Project	<b>IEEE 802.16 Broadband Wireless Access Working Group</b> < <a href="http://ieee802.org/16">http://ieee802.org/16</a> >	
Title	<b>Time Frequency mapping of Downlink MIMO in OFDMA PHY</b>	
Date Submitted	<b>2005-103-13</b>	
Source(s)	Danny Stopler, Ran Yaniv, Tal Kaitz, Naftali Chayat, Vladimir Yanover  <b>Alvarion Ltd.</b>	<a href="mailto:danny.stopler@alvarion.com">danny.stopler@alvarion.com</a> <a href="mailto:ran.yaniv@alvarion.com">ran.yaniv@alvarion.com</a> <a href="mailto:tal.kaitz@alvarion.com">tal.kaitz@alvarion.com</a>
Re:	Call for comments, maintenance task group	
Abstract		
Purpose		
Notice	This document has been prepared to assist IEEE 802.16. It is offered as a basis for discussion and is not binding on the contributing individual(s) or organization(s). The material in this document is subject to change in form and content after further study. The contributor(s) reserve(s) the right to add, amend or withdraw material contained herein.

# Time Frequency Mapping of Downlink MIMO in OFDMA PHY

Figure XXX – N-antenna STC transmission

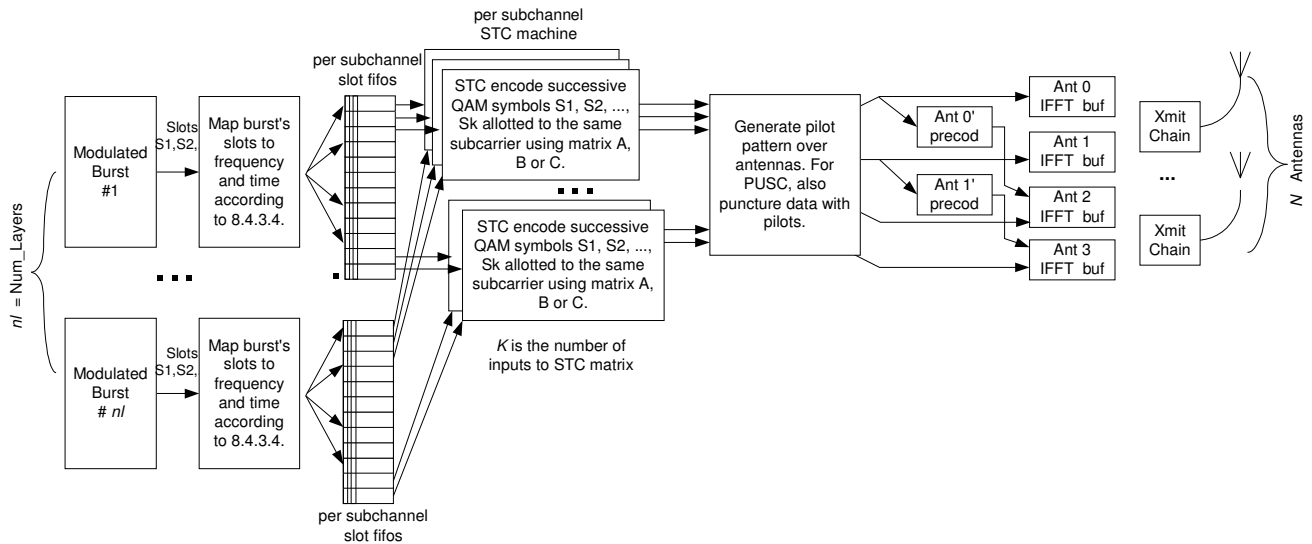
[Add text at the end of Section 8.4.8.2.3]

The multi antenna transmission is described in terms of slots, where the burst modulators fill (frequency first) a vector of per sub-channel fifos. The input of each fifo is slot based and the output of each fifo is OFDMA-symbol based. Each such fifo is connected to an independent STC machine, which reads the slots, processes them, and finally outputs STC encoded data symbols per antenna for the corresponding subchannel.

The multi antenna transmission is defined differently for horizontal (Num-Layers>1) and vertical coding (Num-Layers=1). Vertical coding indicates transmitting the coded stream of a single burst over multiple antennas, while horizontal coding indicates transmitting a separate burst per antenna. More specifically the schemes depicted in figure XXX are elaborated below. The sequence  $\{S_k\}$  in the figure depicts the data QAM symbols allotted to the same subcarrier over consecutive in a subchannel over one OFDMA symbol duration time.
